3" x 18" BELT SANDER-SINGLE SPEED

Model 9910(MJ,MME)

3" x 18" BELT SANDER

Model 9911(MJ,MME)

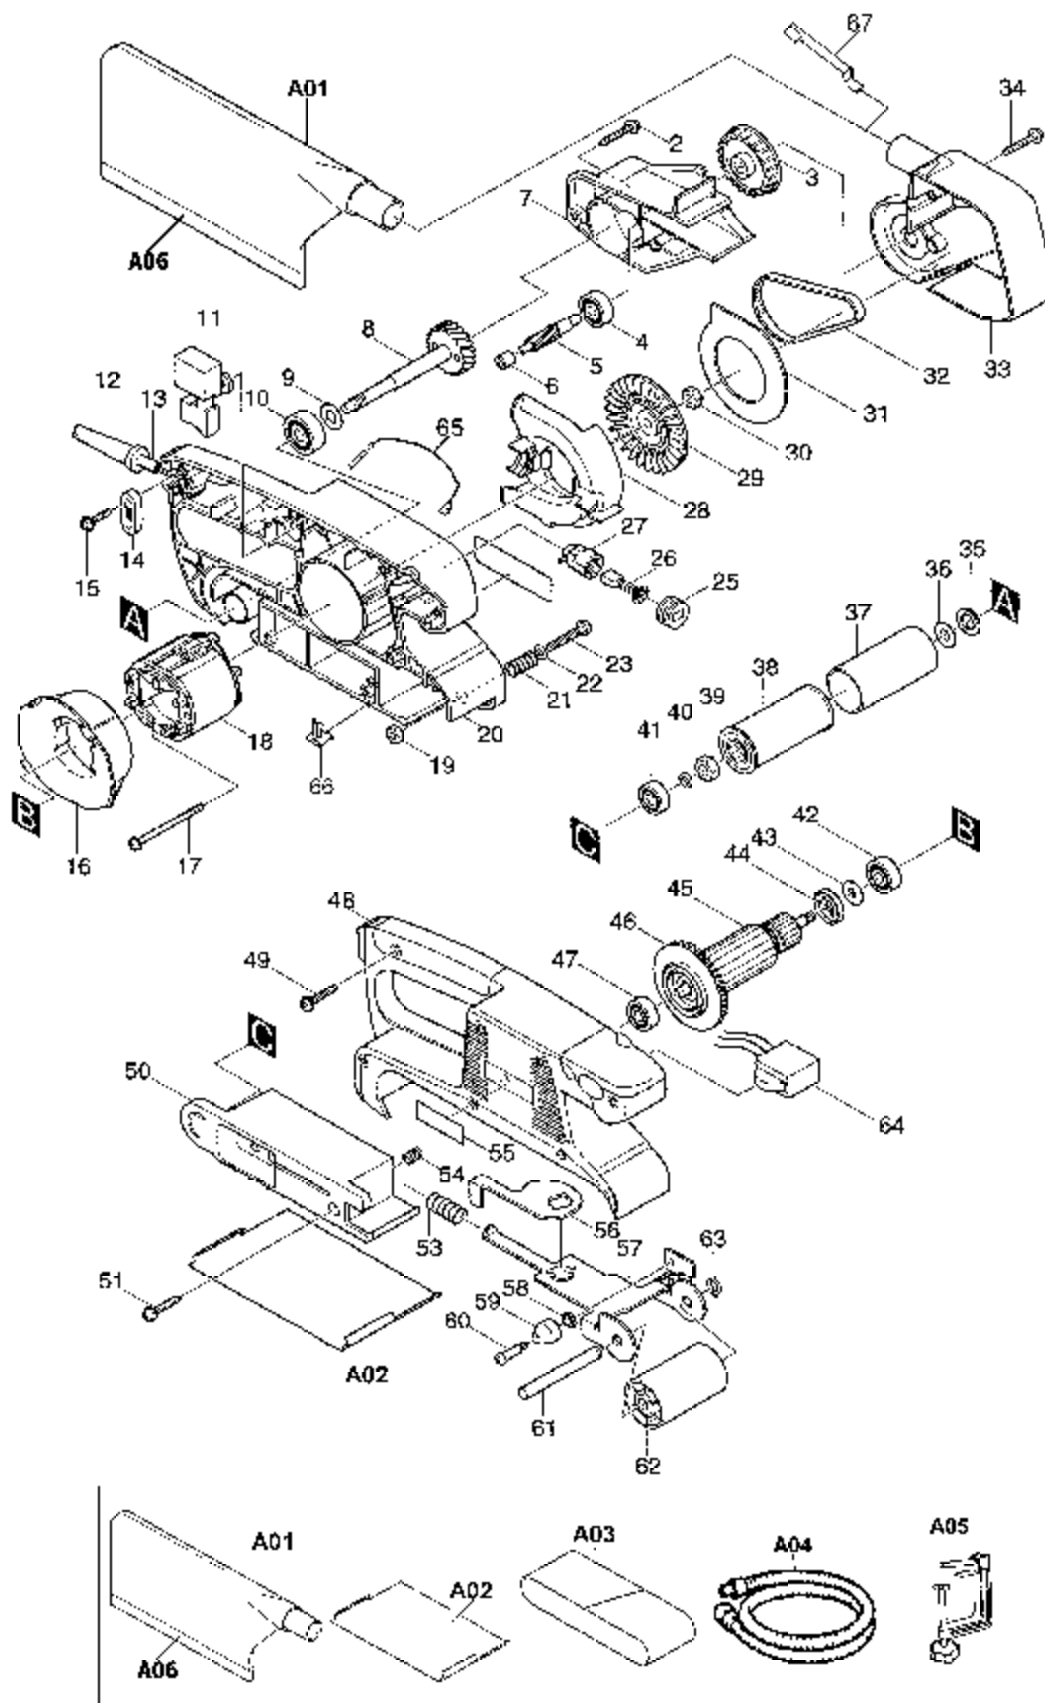
* SEE SERVICE CHANGES

1. Change on Belt Cover and addition of Earth Supporter and Earth Plate.

Earth Supporter and Earth Plate have been added and Belt Cover changed to prevent generation of static electricity.

Item No.	Description	Type 1	Type 2
33	Belt Cover/Belt Cover Set	416415-5	183021-8
66	Earth Supporter	-----	344703-9
67	Earth Plate	-----	344701-3
Serial No.	9910	~ 8778E	8779E ~
	9911	~ 8159E	8160E ~

Above parts are completely interchangeable as a set.
